**COMMENTS ON EPA
HAZARD RANKING SYSTEM DOCUMENTATION RECORD
BRANDYWINE DEFENSE REUTILIZATION AND MARKETING OFFICE
(DRMO)**

SUBMITTED TO USEPA BY THE UNITED STATES AIR FORCE

9 October 1998

ATTACHMENT C
WETLAND DELINEATION
BRANDYWINE DRMO SITE

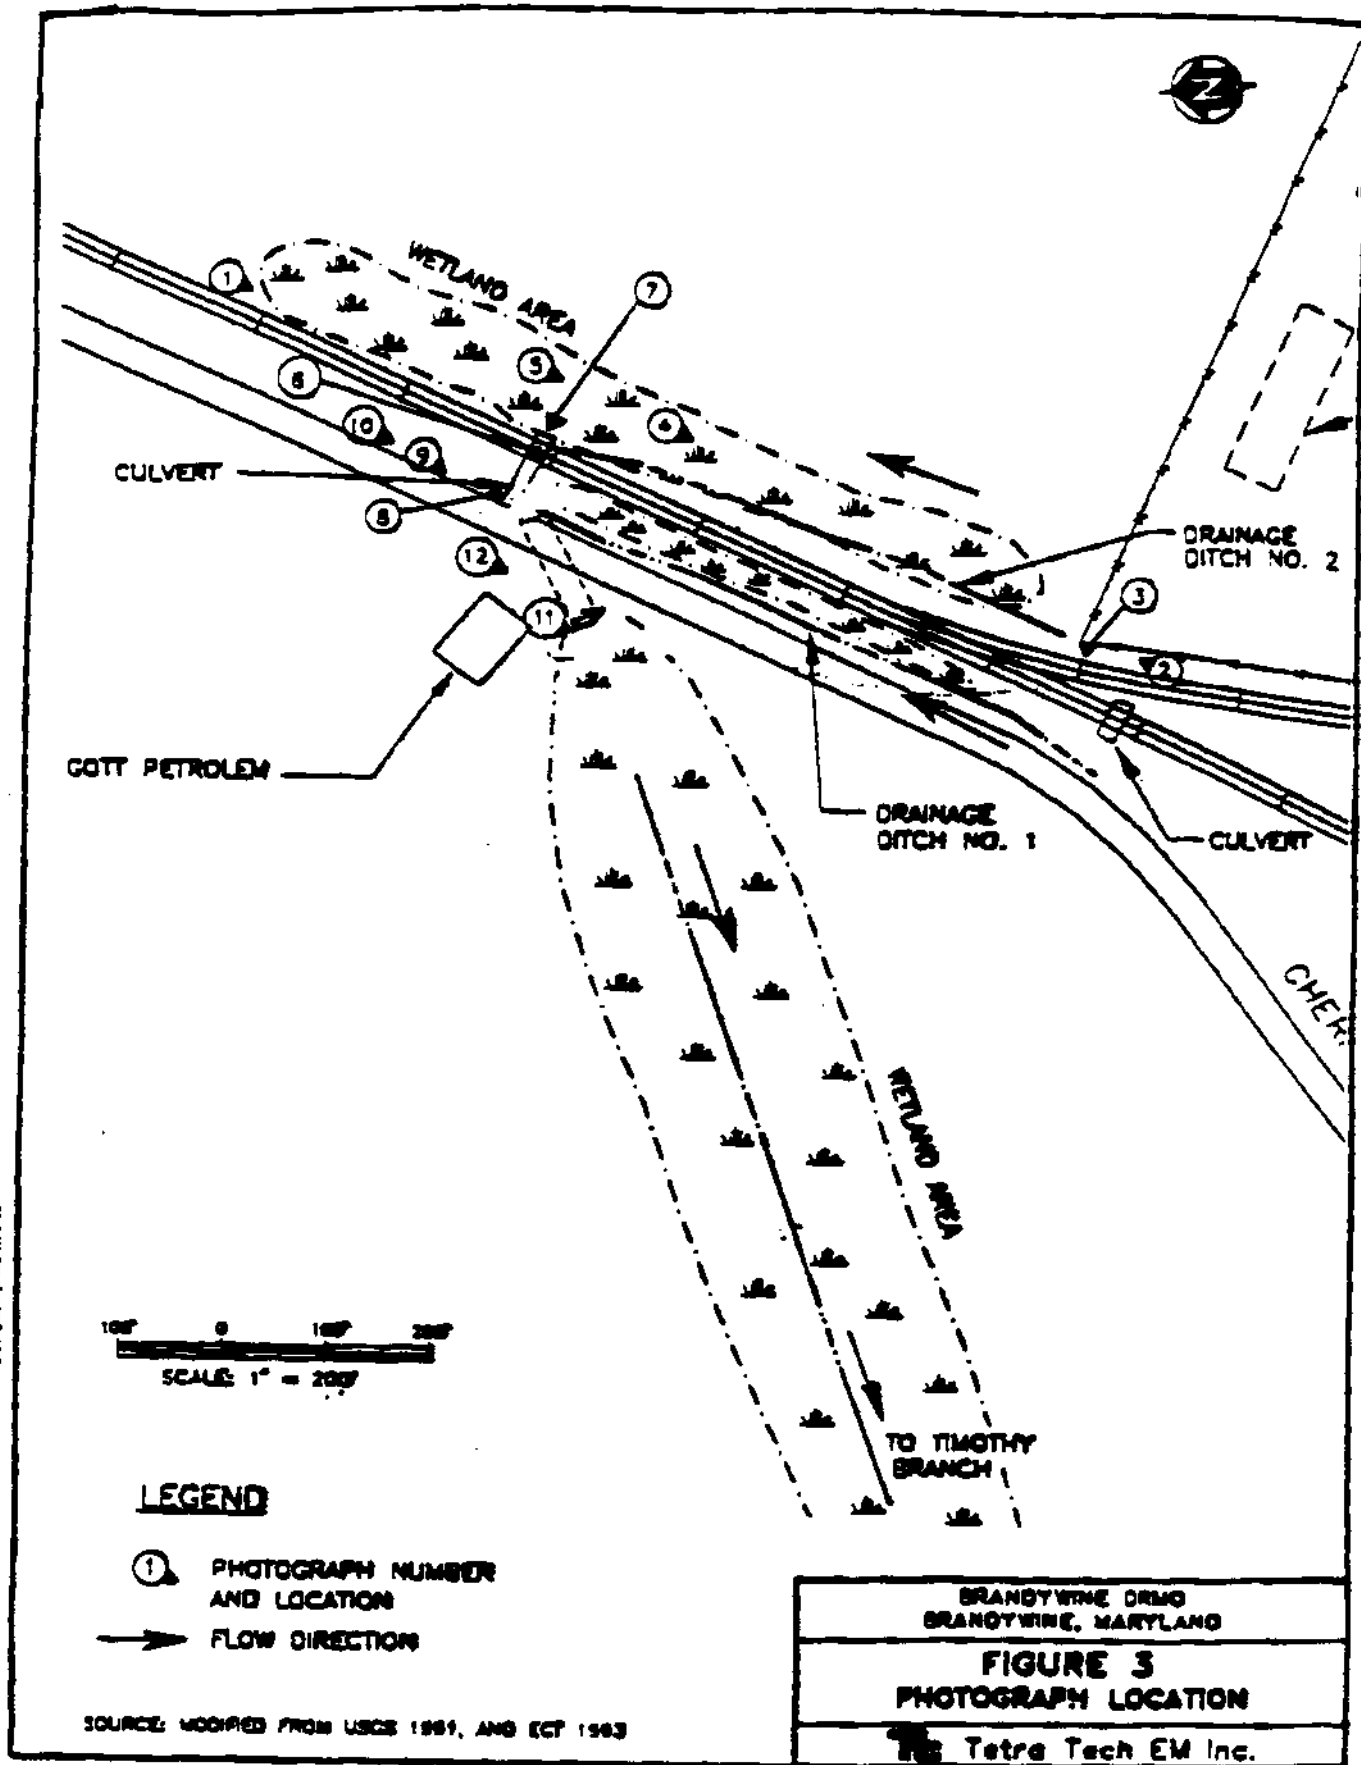
Area 2 (Drainage Ditch 2), represented by Data Point 1, was determined not to be a wetland because it is dominated exclusively by barnyardgrass (*Echinochloa crus-galli*), which is considered to be facultative upland (FACU) in the northeastern United States, including all of Maryland (Reed, 1988). Soils appear to be fill soils placed to create an elevated bed for a former railroad track, now removed. Area 2 is a weakly defined depression on the fill soils that likely accumulates runoff from the adjoining compacted soils on the railroad bed and the DRMO Site. The soils in this depression are heavily compacted and may pond runoff for brief periods following heavy rainfall. Frequent tire ruts suggest that periods of saturation or shallow inundation do occur. But the fact that the vegetation is not dominated by plant species typical of wetlands (even wetlands in disturbed areas) suggests that any periods of saturation are brief and episodic. Furthermore, the soils in the depression did not display the puddled (cracked) surface that would be expected if runoff had been present in the area for an extended period earlier in the 1998 growing season.

Data Point 2 was collected from an area outside of the depression (Area 2) for the purpose of obtaining upland data for comparison against Data Point 1. The vegetation is dominated by weedy species typical of disturbed areas. Although the two dominant species are facultative (FAC) and facultative wetland (FACW), the vegetation also includes several associated species that grow predominantly in disturbed upland areas.
